SUBDIVISION REVIEW SHEET**CASE NO.:** C8-2016-0216.0A**ZAP DATE:** October 17, 2017**SUBDIVISION NAME:** Allen Terrace Subdivision**AREA:** 1.98**LOT(S):** 5**OWNER/APPLICANT:** (John Dan McMahan III and Artemis Land Partners)**AGENT:** (Rivera Engineering)**ADDRESS OF SUBDIVISION:** 1401 Allen Road**GRIDS:** MF22**COUNTY:** Travis**WATERSHED:** Eanes Creek**JURISDICTION:** Full-Purpose**EXISTING ZONING:** Single Family**MUD:** N/A**NEIGHBORHOOD PLAN:** N/A**DISTRICT:** 8**PROPOSED LAND USE:** SF-2**ADMINISTRATIVE WAIVERS:**

Re: **Allen Terrace Subdivision – 1401 Allen Road**
Final Subdivision Plat Case No. C8-2016-0216.0A
Formal Request for Variance from LDC Section 25-4-175(A)(2)

SUBJECT: C8-2016-0216.0A Allen Terrace Subdivision, Flag Lot variance request

TREE TAG	SIZE & DESCRIPTION
2301	23" LIVE OAK
2303	18" LIVE OAK
2304	18" LIVE OAK
2305	20" LIVE OAK
2306	20" LIVE OAK
2307	24" LIVE OAK
2308	19" CEDAR
2309	19" CEDAR
2310	20" LIVE OAK

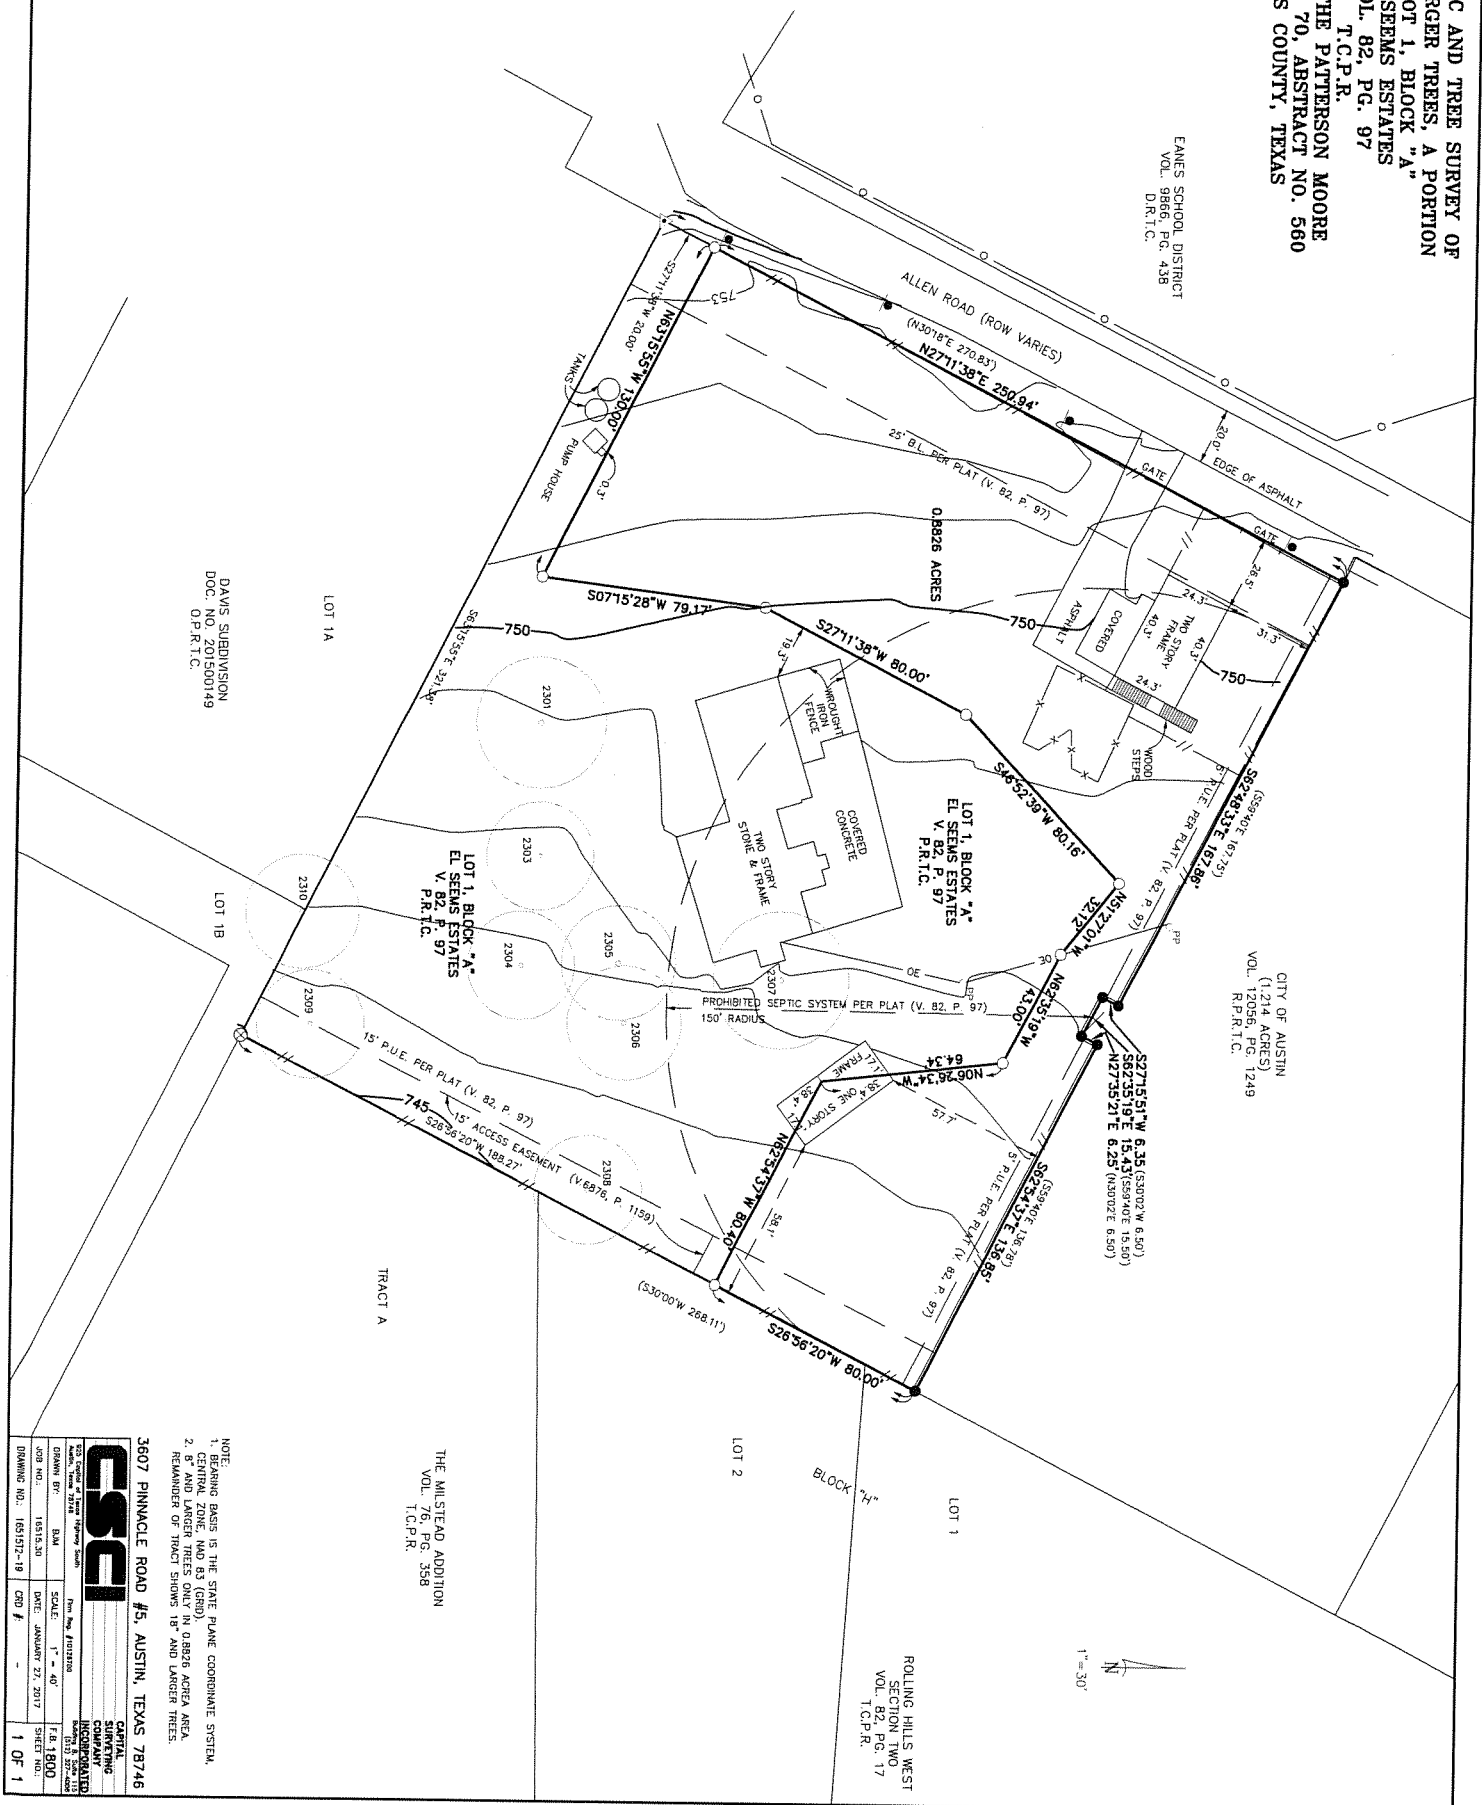
The applicant has provided a tree survey to arborist staff with the City of Austin and the arborist have no objections or further recommendations.
